N3300A-01A

S E R V I C E N O T E

N3300A Electronic Load Full Rack Mainframe

CC Source Regulation Out Of Specification

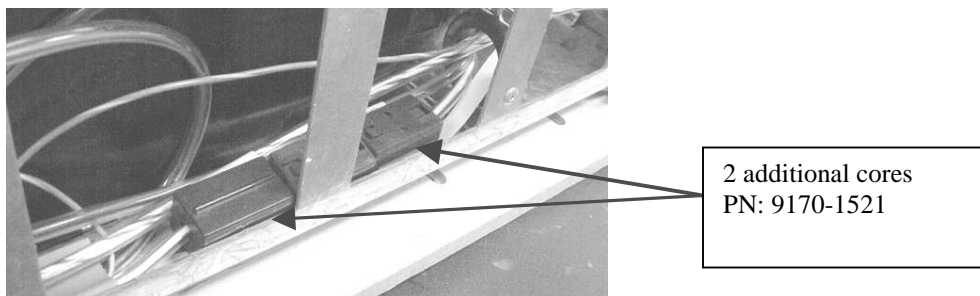
The N3300A mainframe does not meet its CC source regulation specification. The mainframe has a bulk supply which is measuring 318mVp-p common mode noise, the actual specification of this supply is 280mV. To correct the common mode noise problem two additional ferrite clamps (9170-1521) will be added to the output of the bulk supply. By doing this the N3300A will now meet the CC source regulation specification.

Installation of Ferrite Core to the Mainframes**MODELS: N3300A & N3301A**

1. Remove the screws on the front and rear caps, which secure the strap handle on the Gpib board side.

2. Open the side panel cover and install the clamp-on ferrite core PN: 9170-1521 qty 2 side by side to the existing core on the cable.

3. When the installation completed, replace the side panel cover and the strap handle. The curve side of the strap handle facing down. Then secure the caps to front and rear with screws.
